P.O.A.D.P. PLAN for RAY ELLISON / LOOP 410 40

Re: Ray Ellison / Loop 410 40 POADP # 647

P.O.A.D.P REVIEW

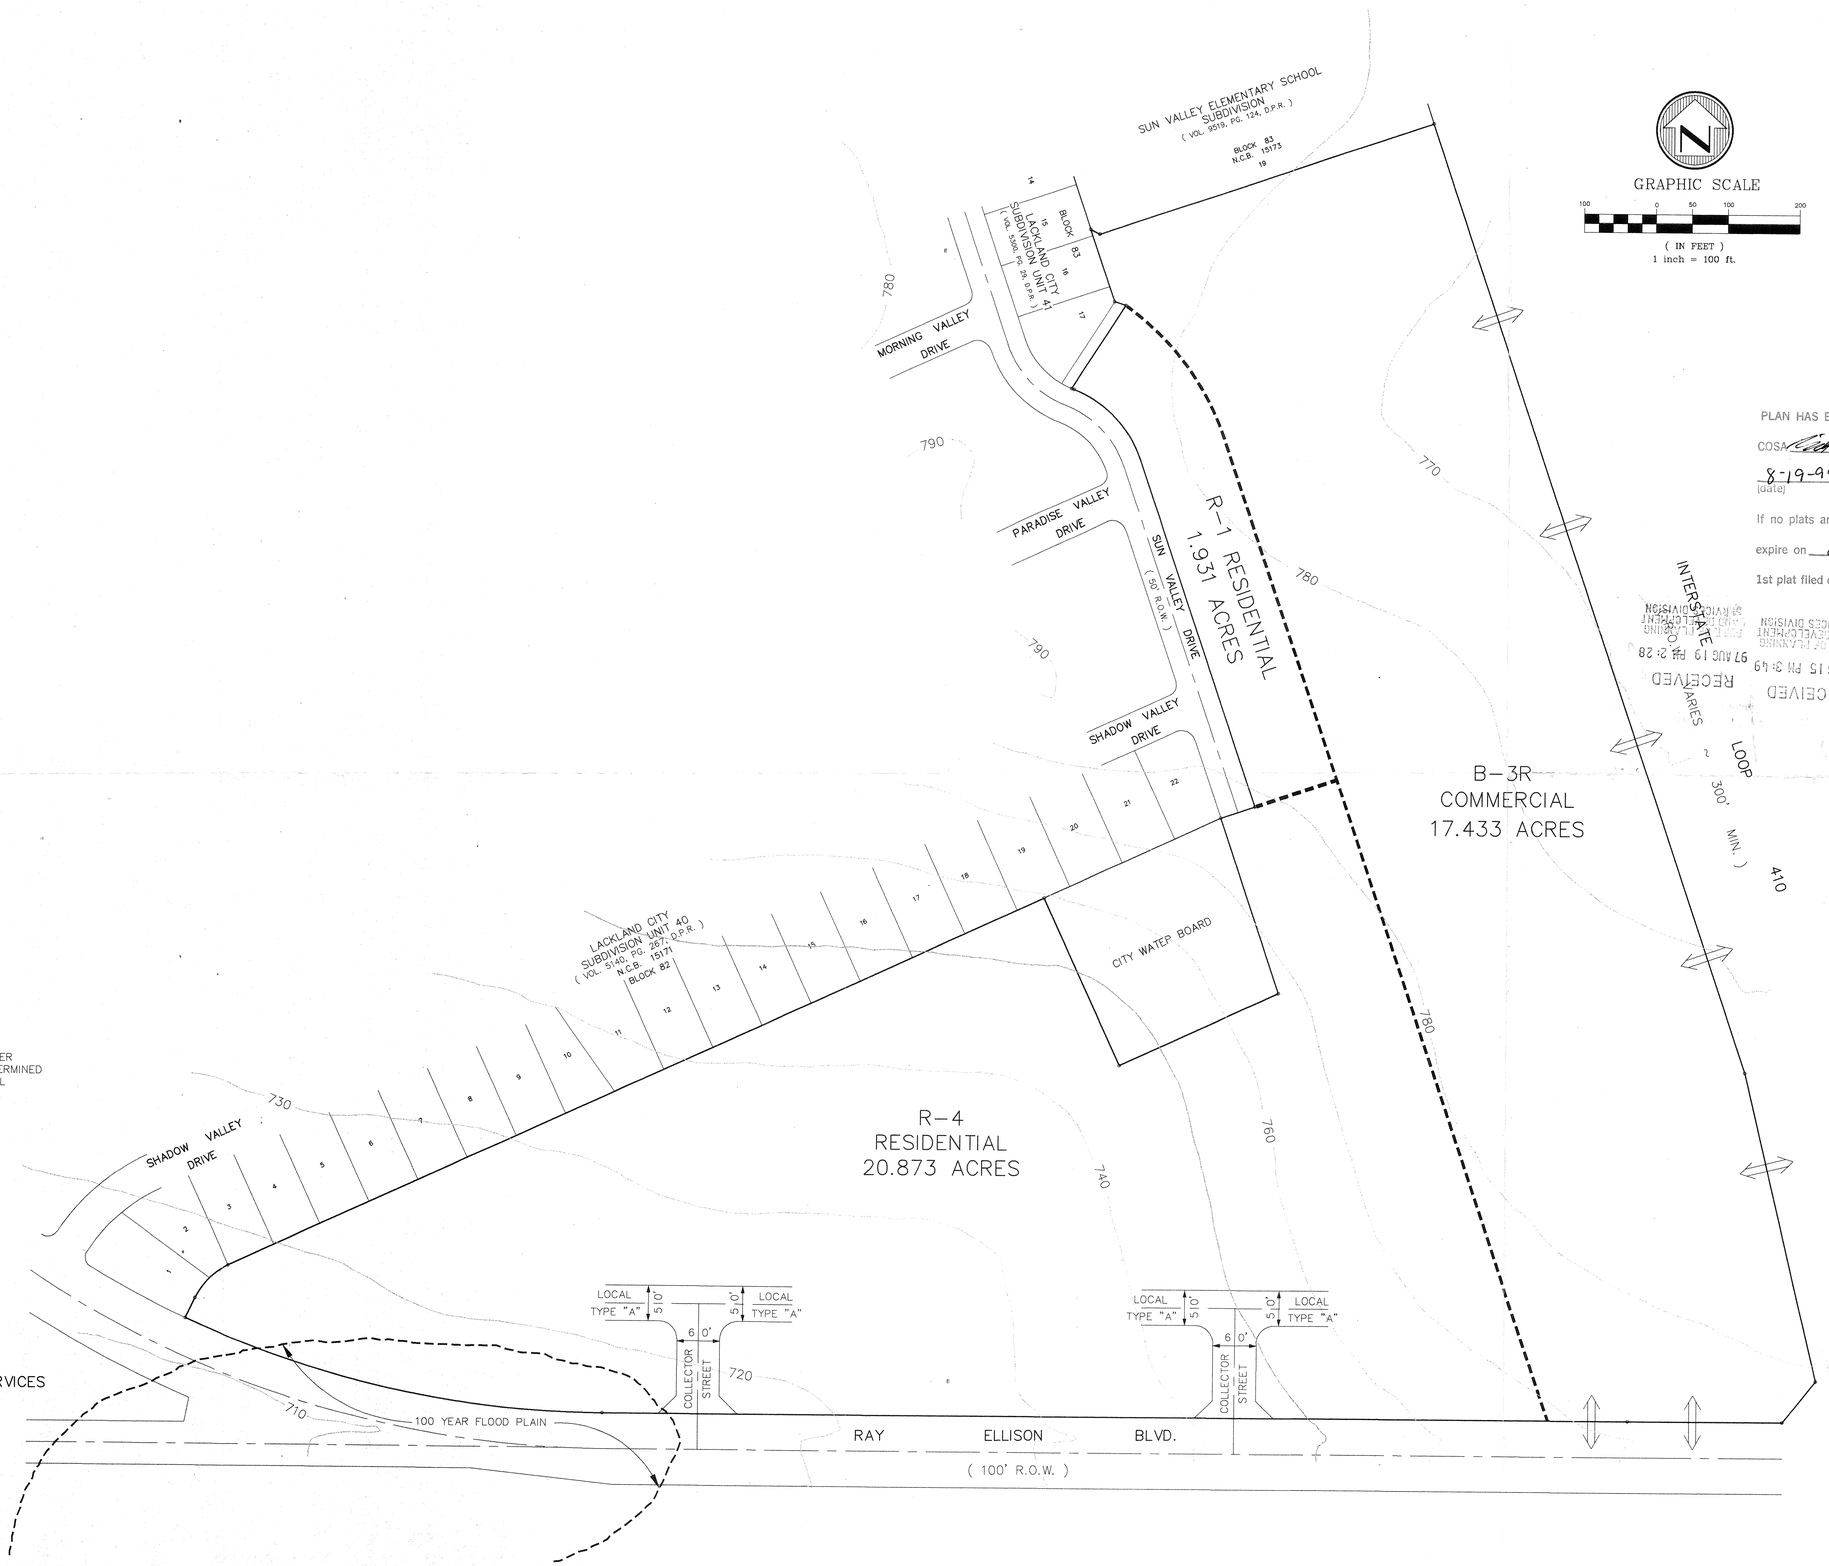
- Based on the topography, a Flood Plain Study and drainage review will probably be required during the platting process.
- In consideration of public safety and convenience, excessive grades by reason of topography should be avoided in street layouts and arrangements.

- Access and R.O.W. issues along State facilities will need to be resolved with the Texas Department of Transportation (TXDOT). For information about these requirements you can contact TXDOT at 615-5814.

- This development will need to comply with tree preservation ordinance #85262. For information about these requirements you can contact Building Inspections at 207-7102.

- It will be expected that you will plat all of the property depicted in your POADP, to include: floodpains, drainage areas and open space.
- I would encourage you to work closely with the school district, so that they can plan accordingly.

- The site is currently zoned (Temp R-1) Temporary Single Family Residence District. An application for a zoning change will have to be filed if this development is pursued.

Comments: Drainage easements will be required and will be address during the platting process

P.O.A.D.P. Reviewed for:	Comments
Noise Mitigation	For residential development directly adjacent to State ROW, the developer shall be responsible for adequate set-back and/or sound abatement.
R.O.W. Requirements	None.
Access Limits/Restrictions	This development is eligible for a maximum combined total of 6 access points along the overall SW Loop 410 frontage. Locations will be as directed by "Regulations For Access Driveways to State Highways".
WPAP Requirements	None

Permit applications along with plans for street, driveway, utility, sidewalk and drainage construction must be submitted to the Texas Department of Transportation for review and approval before working on highway ROW. TxDOT requires that a recorded plat accompany all driveway permit applications. The Owner/Developer is responsible for preventing any adverse impact to the existing drainage system within highway ROW.
